# MEMO

**Re:** 1360 Walton Boulevard, Starbucks Development  
Rochester Hills, Michigan  
Trip Impact Study Addendum

**Figure 1: Future Traffic Volumes**

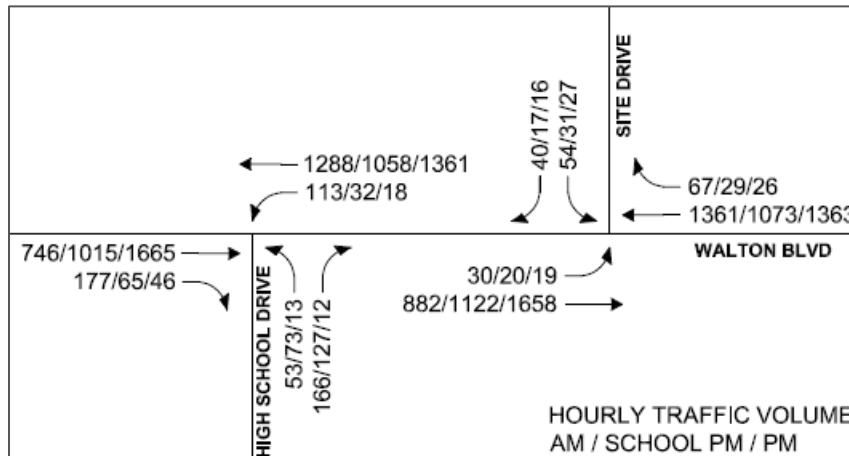
1. Provide further information and potential mitigation measures regarding Starbucks peak hour operations as they correspond to the peak hour operations of the Rochester High School site drive. Specifically, shared center left-turn utilized by both Rochester High School and the proposed Starbucks Drive.
2. Provide a queuing study using comparable Starbucks data as there is still a concern that Traffic will back up onto Walton Blvd.

The peak period queueing at the Rochester High School Drive and the proposed site driveway are summarized in **Table 3**. The result of this analysis shows that there is 20-70 feet available to accommodate vehicle shift tapers during the peak periods.

F&V performed field reviews and data collection during the peak periods. The field reviews showed that the school traffic backs up on Walton Blvd. past the site driveway, as vehicles internal to the site are queued onto the adjacent street. This condition occurs ONLY on school days and is limited to 2% of daily traffic on Walton Blvd. for a window of approximately 20 minutes before school starts in the morning and 20 minutes before school dismisses in the afternoon. Throughout the remainder of the day, the vehicle queueing in the center left-turn lane does not impact the operations of the adjacent site driveways. During the periods of the year when school is not in session, i.e., weekends, Holidays, Summer Break, etc. there is NO impact from the High School operations.
